Enclosure 2

**Revisions to SSAR Section 2.3 and ER Section 2.7 for
Responses to RAIs 2.3.1-1 (revised), 2.3.1-2, 2.3.1-3, 2.3.1-4,
2.3.1-5, 2.3.1-6, 2.3.2-1, and 2.3.2-2**

The following application revisions reflect the responses to RAIs 2.3.1-1 (revised), 2.3.1-2, 2.3.1-3, 2.3.1-4, 2.3.1-5, 2.3.1-6, 2.3.2-1, and 2.3.2-2 contained in Enclosure 1 to this letter.

Serial No. 04-318
Docket No. 52-008
Response to 5/12/04 RAI Letter No. 4

Figure 2.3-24 Location of Meteorological Tower Relative to Local Ground Features

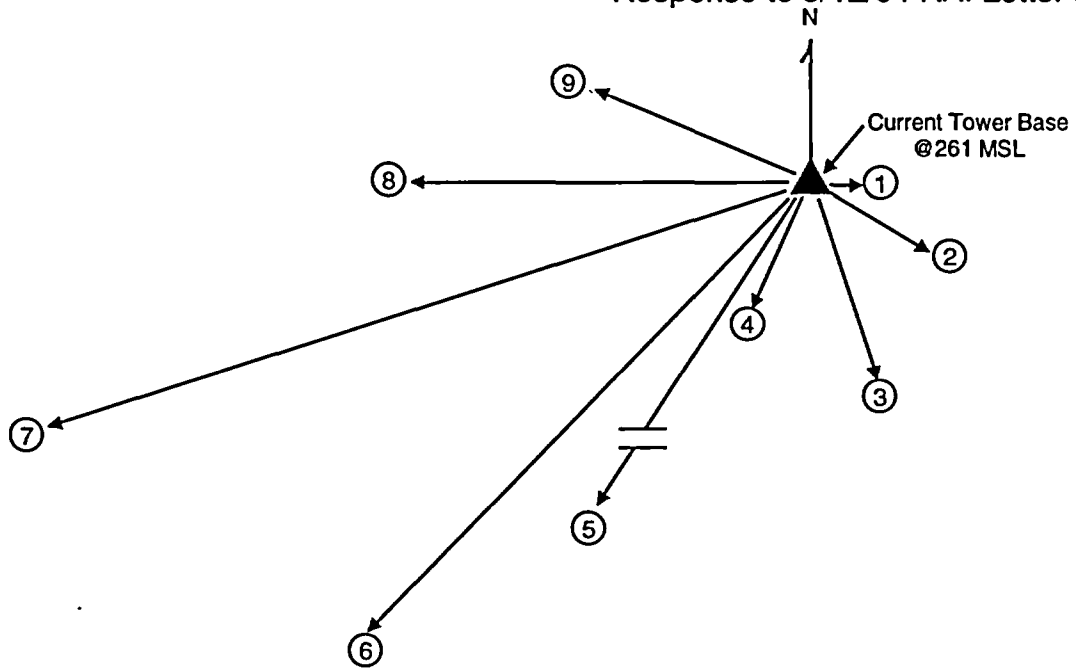
SSAR Figure 2.3-24 will be revised (revised figure is on the next page) to add the following heading above the list of values:

Approximated Directions and Distances

Figure 2.7-2 Location of Meteorological Tower Relative to Local Ground Features

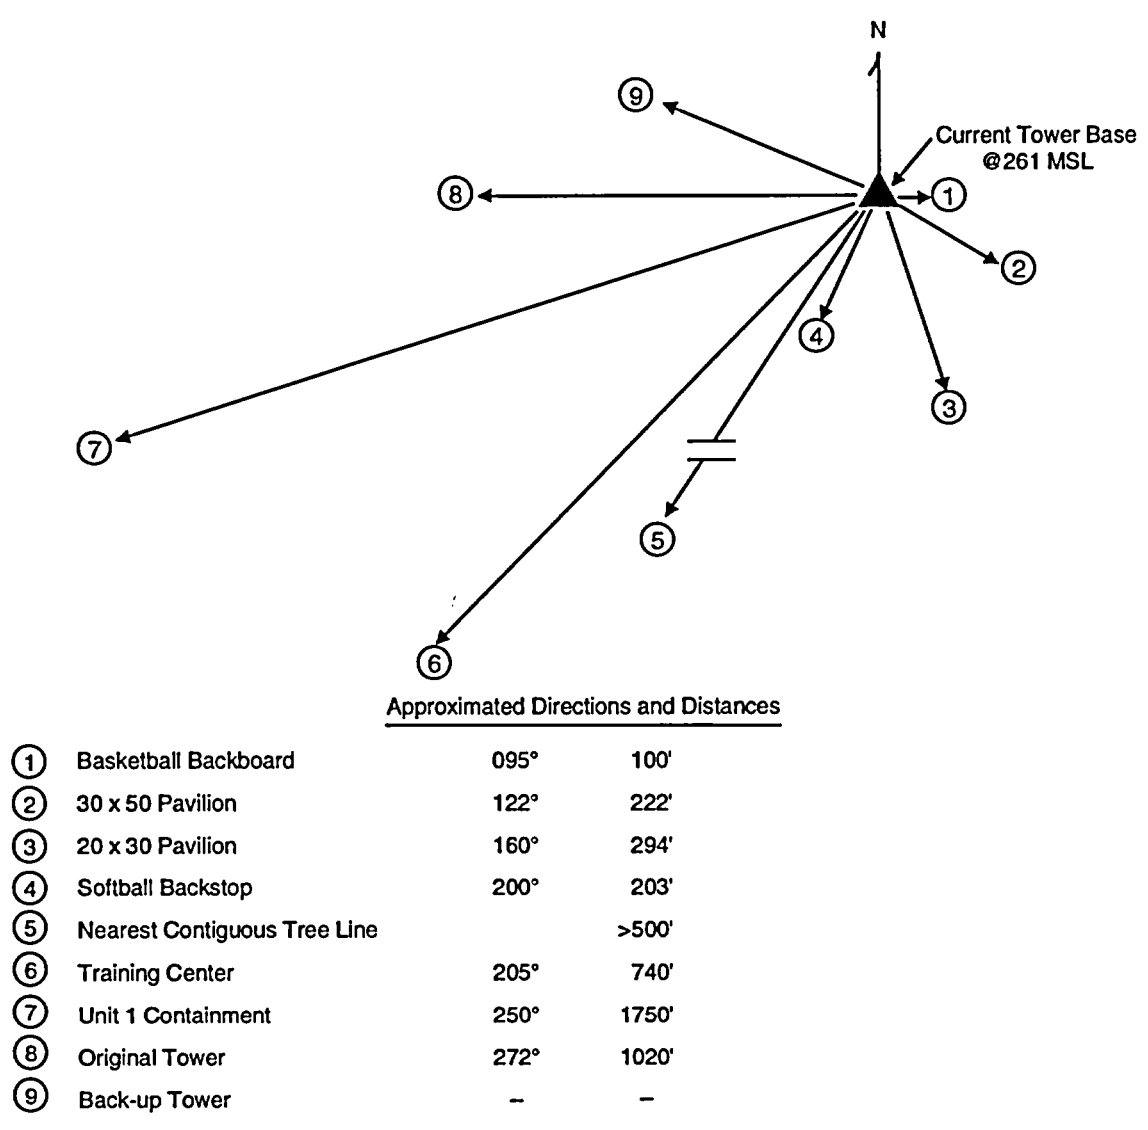
ER Figure 2.7-2 will be revised (revised figure is on the next page) to add the following heading above the list of values:
